Portland General Electric Company
Trojan Nuclear Plant
71760 Columbia River Hwy
Rainier, OR 97048
(503) 556-3713

VPN-001-2005

Trojan ISFSI
Docket No. 72-017
License No. SNM-2509

Revision to PGE-8010, "Trojan Nuclear Quality Assurance Program," to
Reflect Termination of the Trojan Nuclear Plant License Issued Under 10 CFR 50

Figure 1.0-1

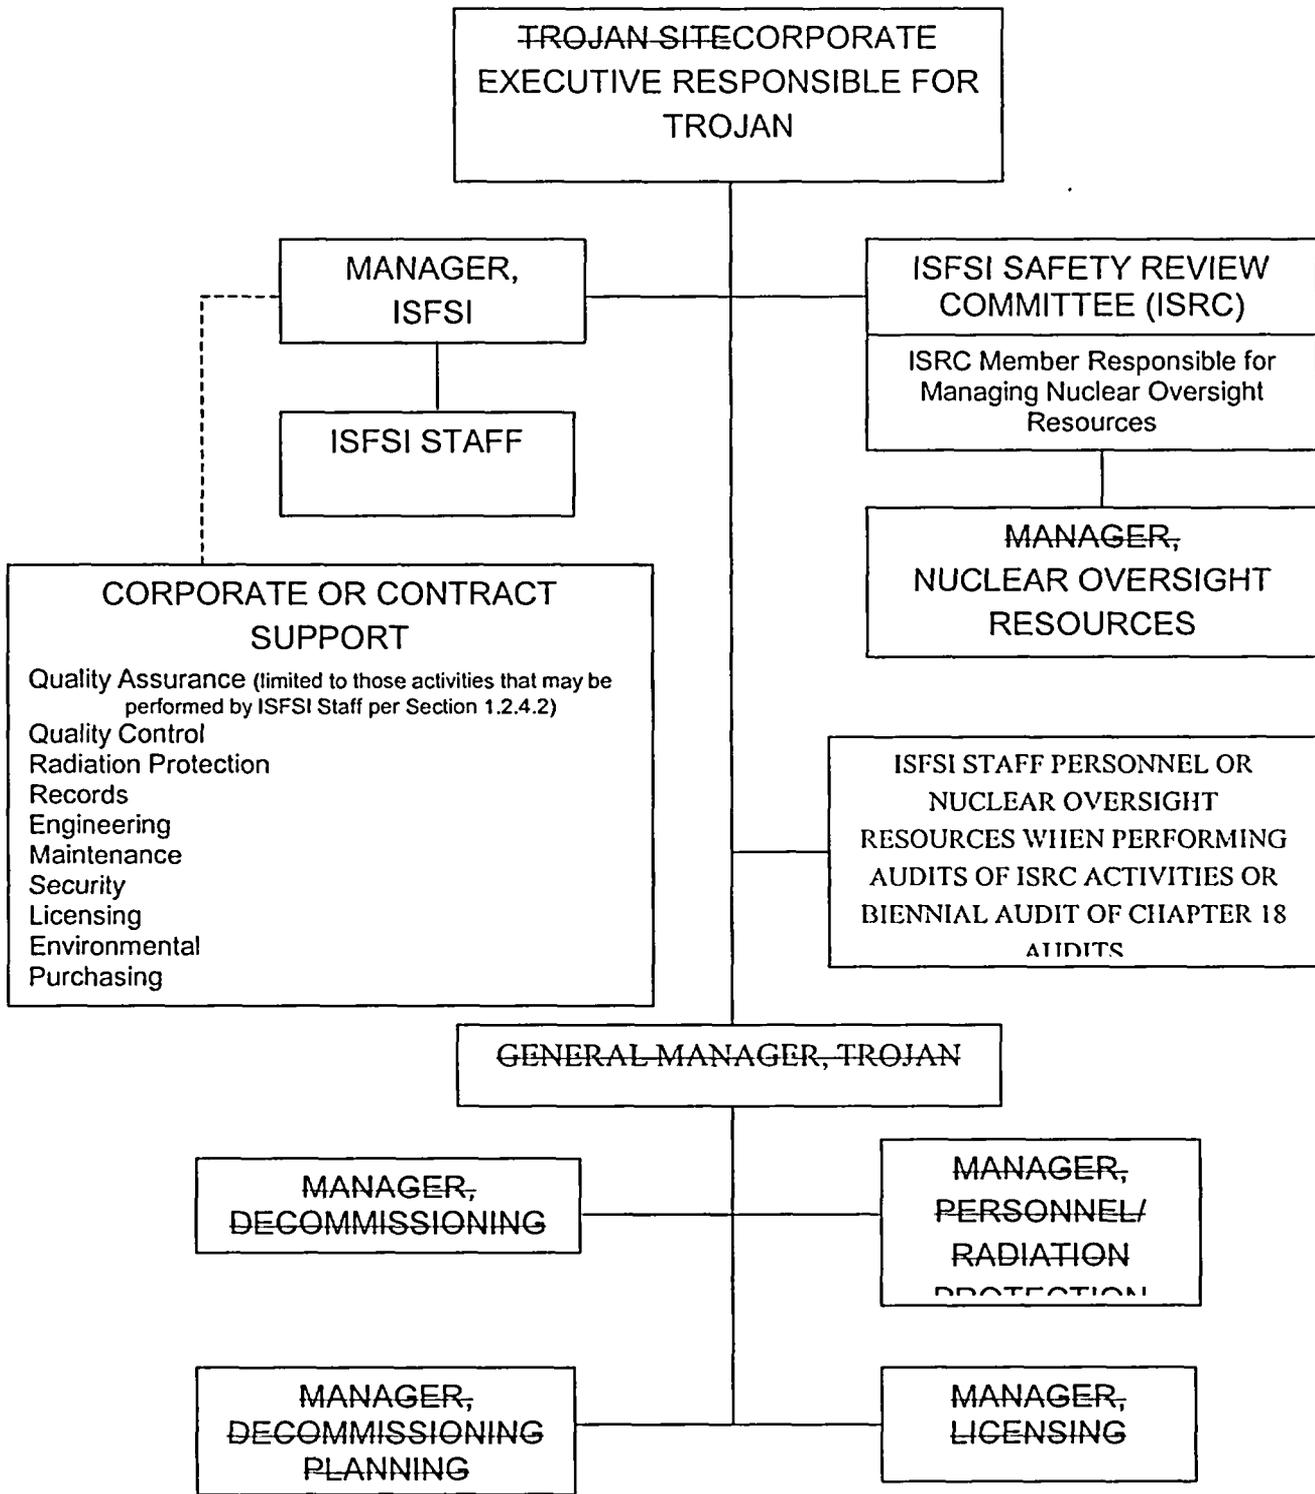
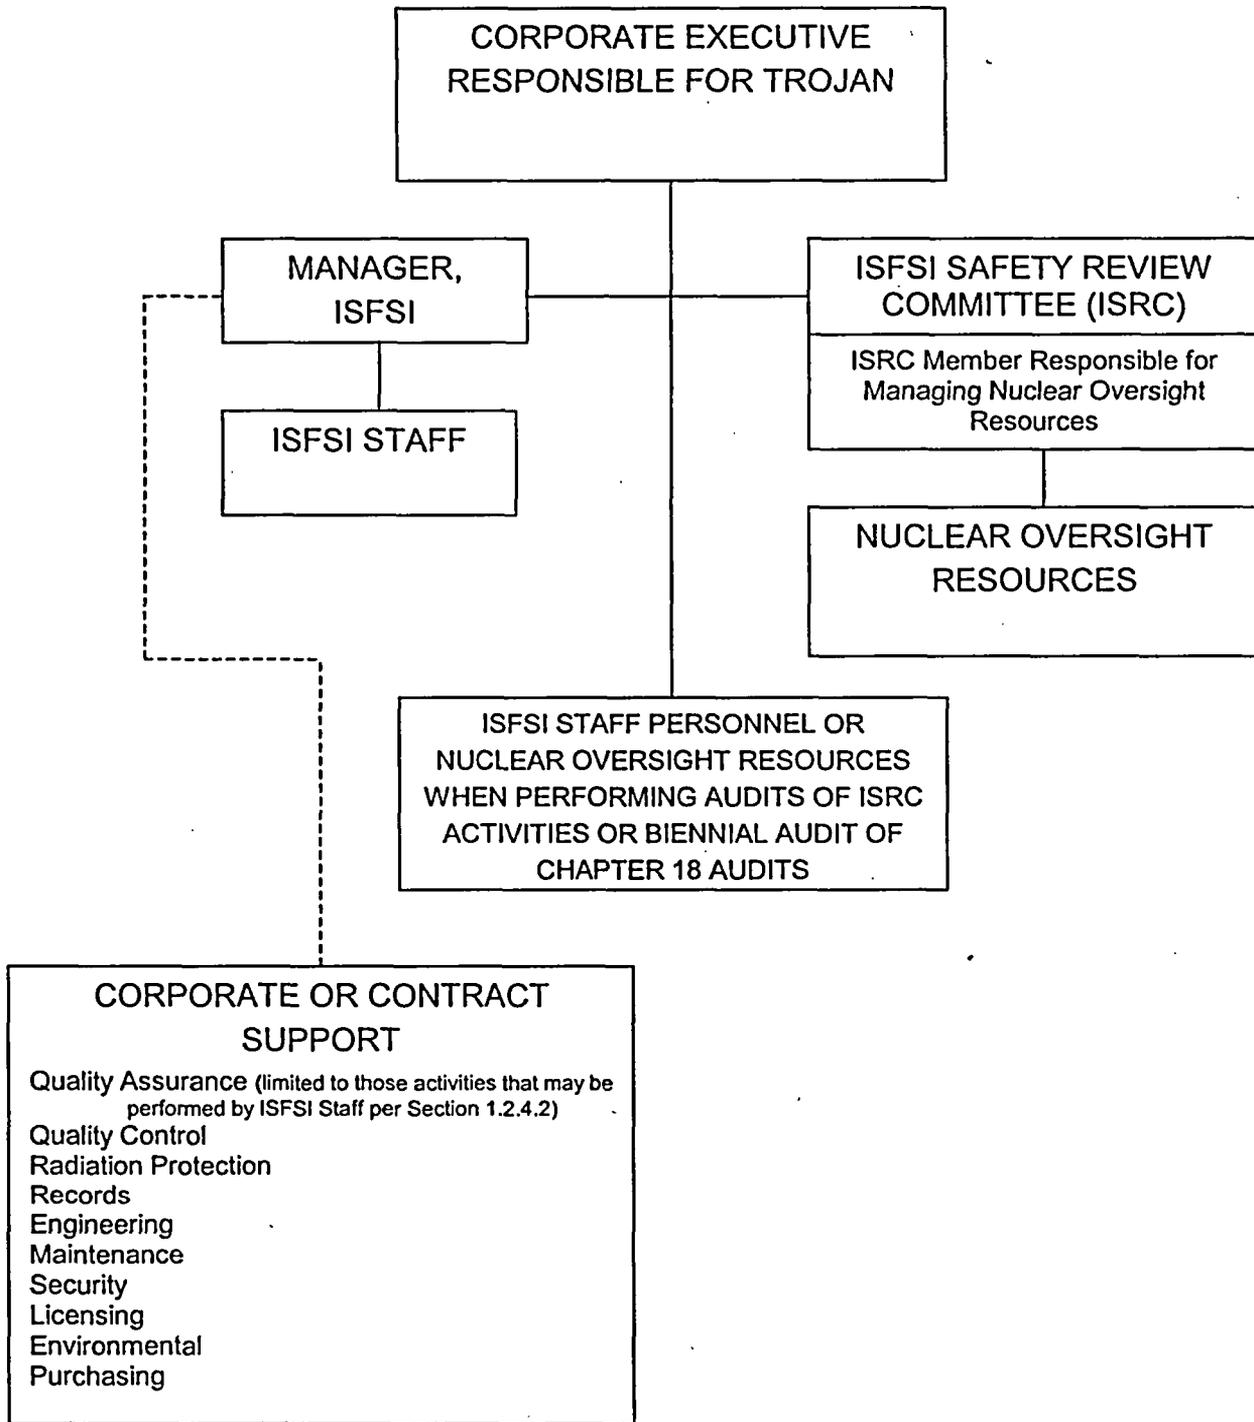
~~The management organization for control of the TNP and the ISFSI is shown in Figure 1.0-1~~ illustrates the functional authorities, responsibilities, and interfaces of persons and organizations performing activities that are governed by and/or required to effectively implement the QA Program. The functional responsibilities indicated in Figure 1.0-1 are further described below.

1.0, Organization, Section 1.2	The Section 1.2 heading is changed from "Organization" to "Assignment of Functional Responsibilities," and the body of Section 1.2 is also revised to reflect the change from specific management position titles to generic titles and/or descriptive text that clearly denote the position function, as discussed further above for changes to the Approval Page.

Figure 1.0-1 illustrates the functional authorities, responsibilities, and interfaces of persons and organizations performing activities that are governed by and/or required to effectively implement the QA Program. The functional responsibilities indicated in Figure 1.0-1 are further described below.
